# TECHNICAL BULLETIN

## MAXNET II 1.2GHZ AMPLIFIER ATTENUATION CONTROL CHANGE AND FIRMWARE UPDATE

Figure 1

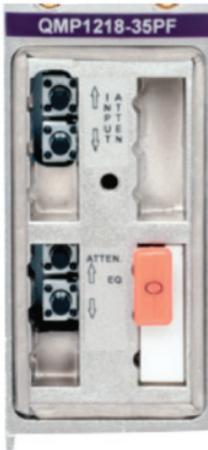
QMP\* series amplifiers with firmware version 6.4 or later will have the ability to lock or unlock the front attenuation push buttons. This can be done manually using the front push buttons (see Fig 01 below) by simply pressing and holding ANY two push buttons on the front until the RED alarm LED changes state (~3s). When the RED LED is fast-flashing (twice the rate of a normal RF alarm condition), the buttons are unlocked and RF attenuators can be adjusted as they always have been in previous models. Each press changes attenuation 0.5dB. When RF levels are set as desired, you can press and hold any two buttons until the LED stops blinking and the control is locked. Alternatively, if you do nothing, then 15 minutes later, the control will auto-lock and the RED LED will stop flashing.

Figure 2

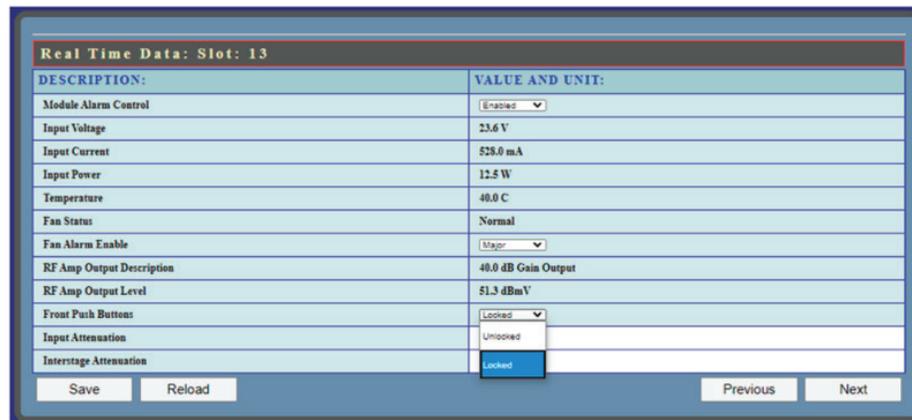
Also note that if you have a MAXNET II chassis with a GEN2 communication module installed then you also have the option to lock/unlock the front push buttons via web GUI, as shown in Fig 02 below, provided that the GUI firmware is 1.9.7 or higher.
